World Forum for Harmonization of Vehicle Regulations

**Collective amendments to Regulations Nos. 12, 14, 16,
17, 21, 25, 32, 33, 94, 95 and 114**

Proposal for corrigenda to Regulations Nos. 12, 14, 16, 17, 21, 25, 32, 33, 80, 94, 95 and 114.

Submitted by the expert from the European Association of Automotive Suppliers*

Figure 2: Dimensions of the 3-D H machine elements and load distribution **a excludes H-point buttons**

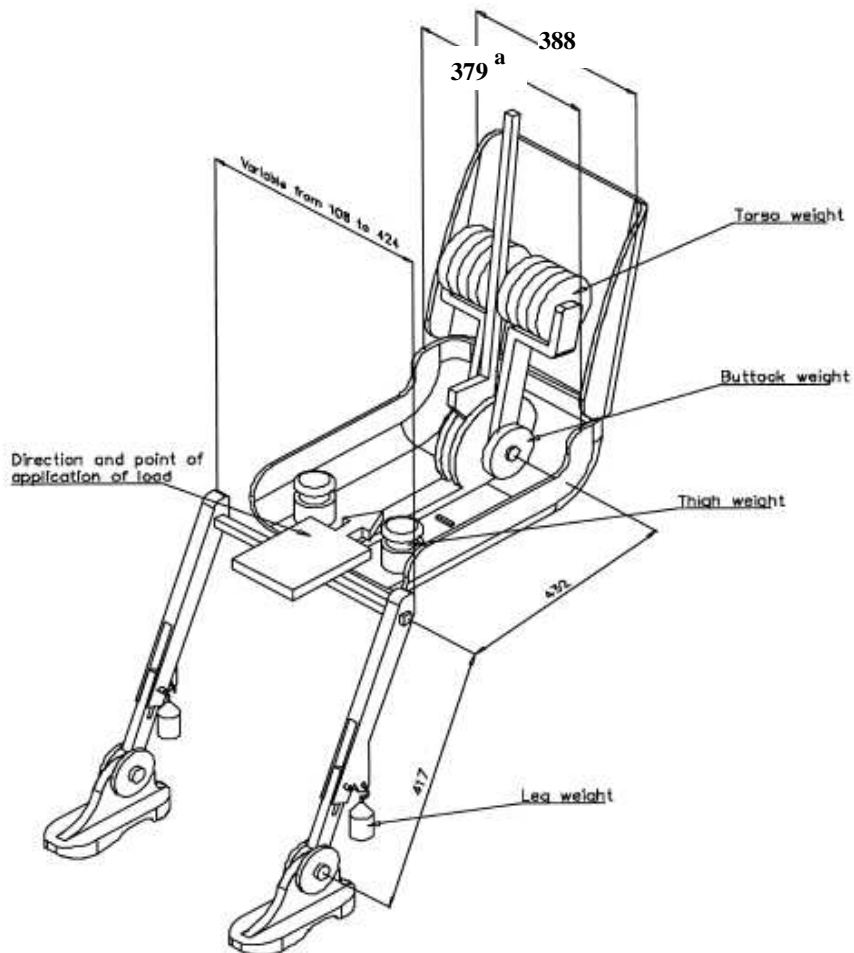
Appendix 1, amend to read:

“DESCRIPTION OF THE THREE DIMENSIONAL “H” POINT MACHINE *

* For details of the construction of the 3-D H machine refer to Society of Automobile Engineers (SAE), 400 Commonwealth Drive, Warrendale, Pennsylvania 15096, United States of America. The machine corresponds to that described in ISO Standard 6549:1999.

Since 1989 all H-point measurement devices produced by SAE have a back width of 388 mm and cushion width of 379 mm instead of 395 mm and 385 mm respectively. This clarification has been introduced into ISO 6459:1999. It is also mentioned in SAE J826-November 2008. The difference has a minor influence on the measurement of the torso angle and H-point in comparison to the allowed tolerances. But those small influences in

H-point and torso angle will be significant for the backset measurement of Regulation No. 17 series 09 and only dummies compliant to actual SAE builds shall be used for backset measurement.
